PARTS DEPARTMENT BULLETIN

BULLETIN NUMBER: 24

SUBJECT: Distributor Change – Gasoline Generators
8.5 BTGA, 12.5 BTG & 15.0 BTG

DISTRIBUTOR CHANGE

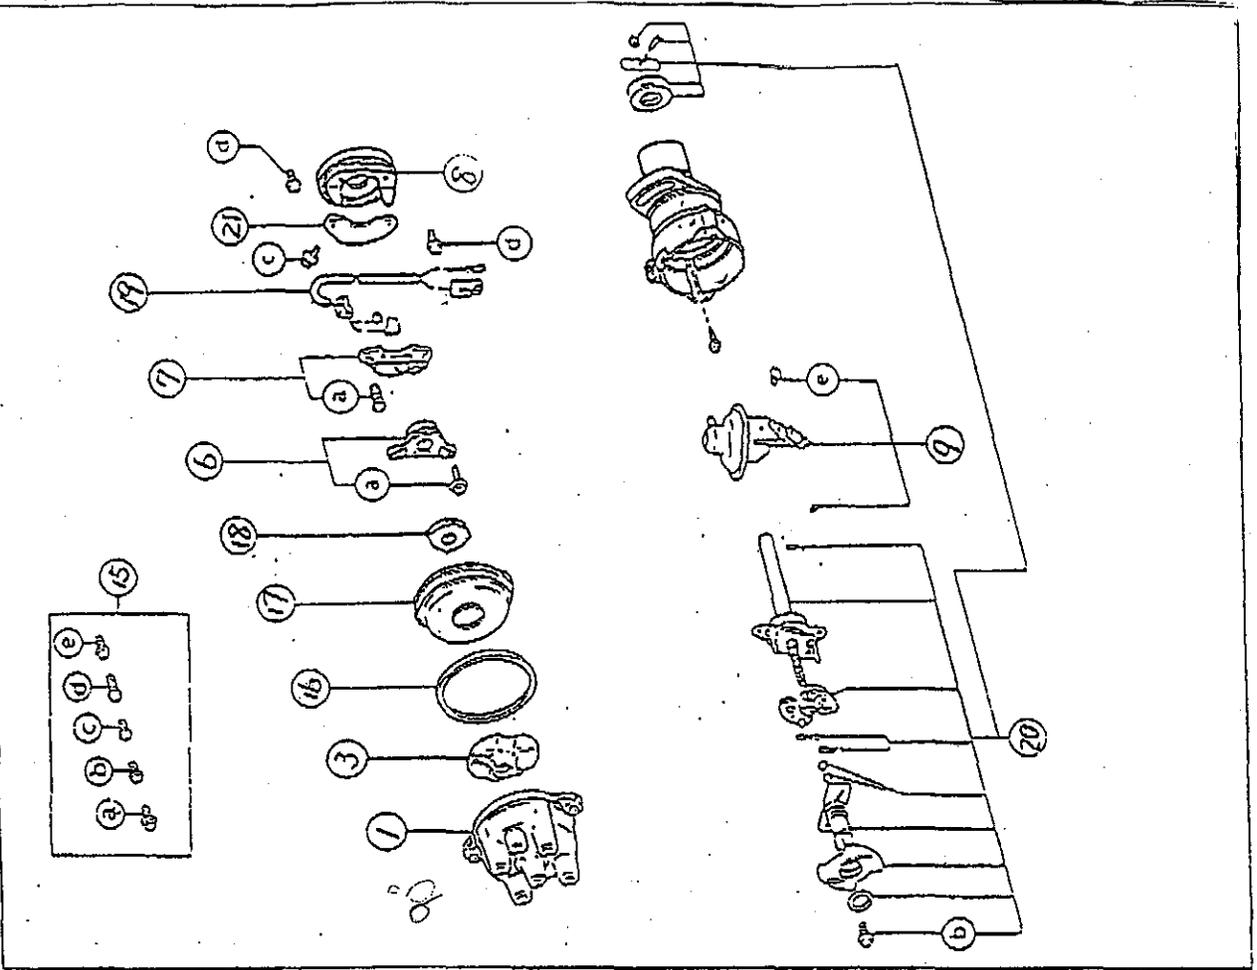
The distributor supplied on the above model generators has changed. The change took place with units produced from approximately July 1997 to current.

If the exact manufacture date is in question, there is an easy way to identify current and early distributors. The sparkplug wire connections on the distributors exit at a 90 degree angle of the cap. The connections on the early distributor exit out of the top of the cap.

Earlier distributor assemblies are interchangeable with the current product. Replacement parts, however, are not interchangeable.

* = NOT AVAILABLE AS LOOSE PART					
CHANGE WAS MADE DURING LAST HALF OF 1997					
THE COMPLETE DISTRIBUTORS ARE INTERCHANGEABLE ALTHOUGH COMPONENTS ARE NOT
